Docket Number:	17-BSTD-02
Project Title:	2019 Title 24, Part 6, Building Energy Efficiency Standards Rulemaking
TN #:	222648
Document Title:	NEMA Response to Comments on NEMA Standard Publication 77-2017 in Docket 17-BSTD-02
Description:	N/A
Filer:	System
Organization:	NEMA
Submitter Role:	Public
Submission Date:	2/21/2018 12:30:01 PM
Docketed Date:	2/21/2018

NEMA Response to Comments on NEMA Standard Publication 77-2017 in Docket 17-BSTD-02

NEMA Response to Comments on NEMA Standard Publication 77-2017 in Docket 17-BSTD-02

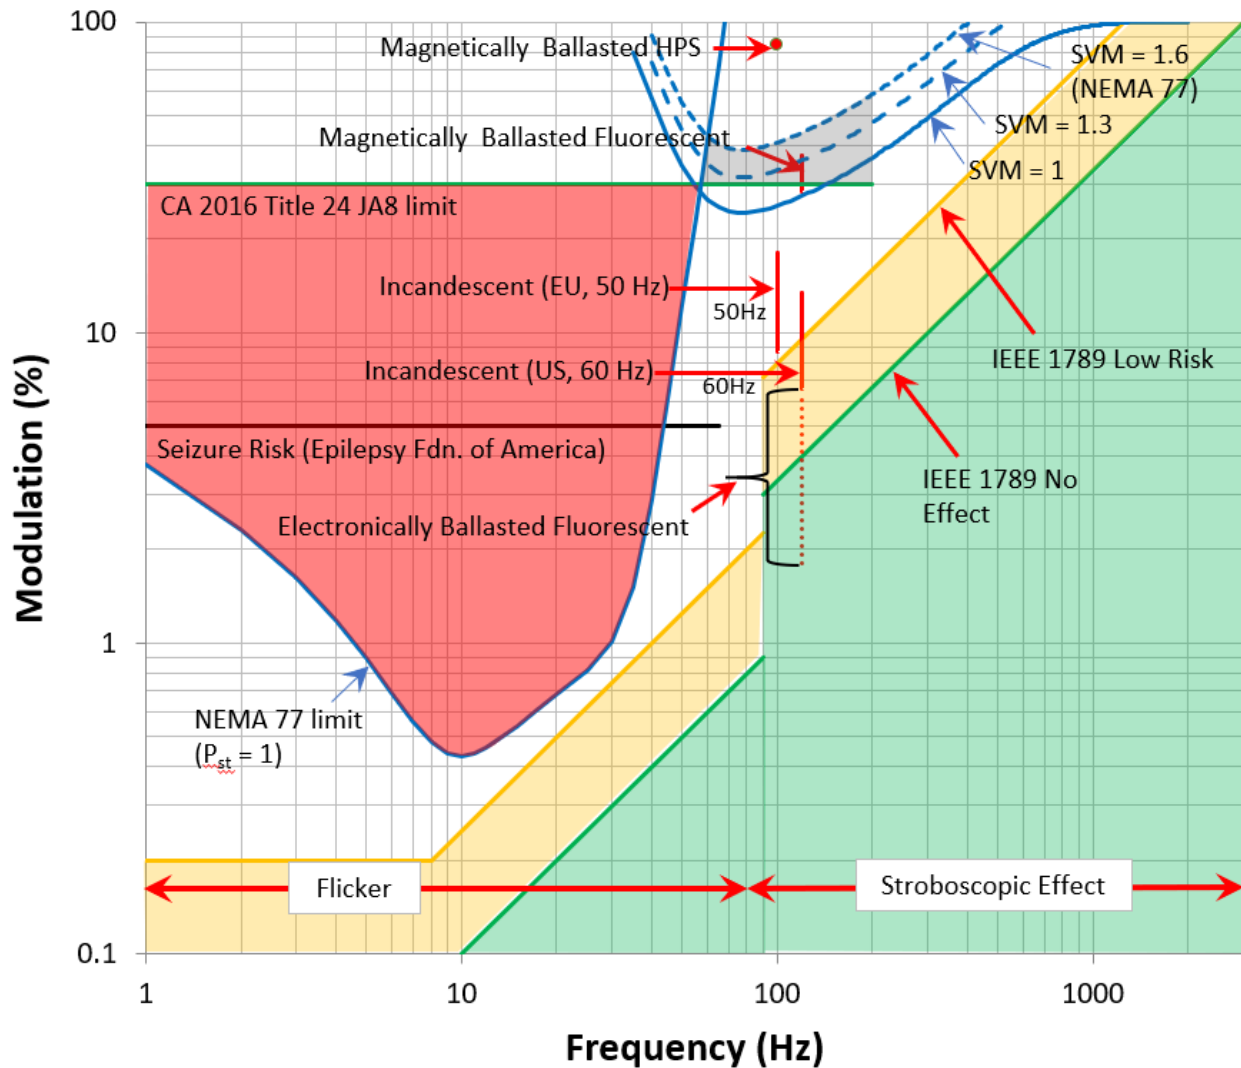
- d. We note the proposed limits of NEMA 77 are much closer to the IEEE 1789 specification than CA Title 24 Joint Appendix JA-10 are. (See Figure below.)

- f. At a visual interference level of 50% (SVM = 1.0) the visual phenomenon of flicker is just barely perceptible if you have been asked to pay attention in highly controlled lab conditions. That is why SVM=1.0 is the appropriate threshold for *observation*. In contrast, Title 24's present specification allows TLA that is visible to nearly 100% of the population, with or without motion (30% modulation depth below about 50 Hz – see figure below).

- The statement that IEEE 1789 recommends half the flicker value of Title 24 is incorrect. The relationship between the two depends strongly on frequency -- it is a “sliding scale” as clearly shown by the figure below. At some frequencies, IEEE 1789 is more than two orders of magnitude stricter than Title 24. NEMA 77 also recommends levels stricter than roughly half the Title 24 limits over much of the frequency range.

For reference the figure of IEEE 1789 at issue cited in previous NEMA comments is repeated below with an additional shaded area to visually demonstrate the performance area required by NEMA 77. We note the conditions given in the figure for non-LED light sources (in red) are based on measurements done at Pacific Northwest National Labs (PNNL), except for the line for 50 Hz incandescent lamps, which came from Shackle and Erwin.
